Service Bulletin

File in Section: -
 Bulletin No.: 15-NA-058
 Date: August, 2016

Subject: Squeak, Squawk, Creak or Popping Noise Originating from Rear Axle

Brand:	Model:	Model Year:		VIN:		Engine:	Transmission:
		from	to	from	to		
Chevrolet	Volt	2016	2017			All	All

4336304

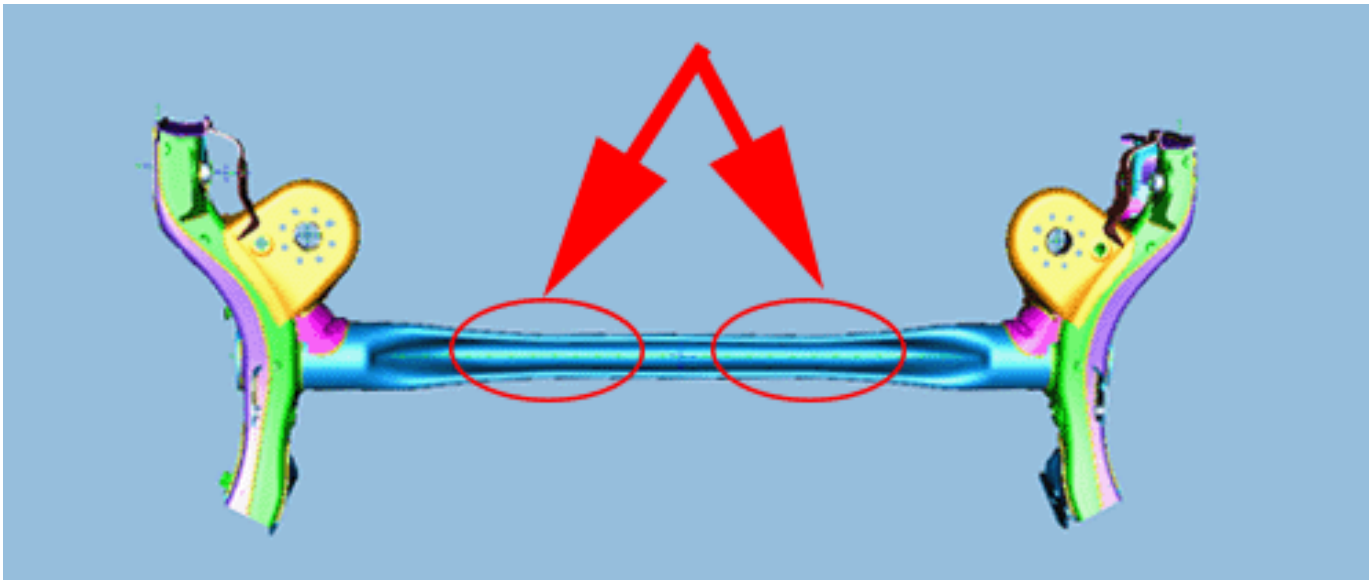
3. Pull down on one side to get the axle to twist. The creak noise should be heard or felt as indicated in the above illustration areas.
4. If the noise is verified, replace the rear axle. Refer to Rear Axle Replacement in SI.
